POSITION BY EHPA and EPEE

ErP ENER Lot 1 – Eco-design and labelling requirements for boilers: EC working documents *February 2012*

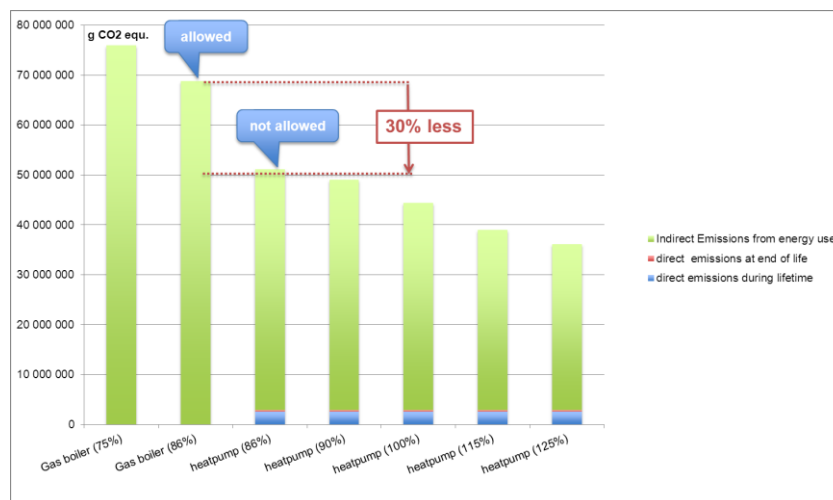
The ecodesign requirement tries to achieve a level of ambition where it is not necessary and lacks a level playing field. From an ecodesign perspective, separate requirements for heat pumps are not useful in view of energy savings in Europe. Products with low CO₂ emissions have to achieve higher targets than the conventional technologies which have higher CO₂ emissions, even at the same levels of efficiency, as shown in the graph below:

We understand that requirements should be set in order to prevent poor quality heat pumps from entering the market to replace existing technologies, which do not improve on energy use reductions and CO₂ emissions. Therefore, we feel that the present first tier is acceptable, but that a 3rd tier should be deleted. At this point, a level playing field will be lost, and competitive heat pumps will be prevented from entering the market. On top of this, the 3rd tier will create an even bigger price difference between technologies and will consequently increase the barrier for more environmentally friendly products. As this is a new and growing technology, it is necessary to drive it, not to bring it to a halt. As such, EHPA and EPEE request the deletion of the 3rd tier for minimum efficiency requirements of heat pumps, and postpone it until the next revision of the ecodesign requirements. At that time it will be possible to re-evaluate new levels.
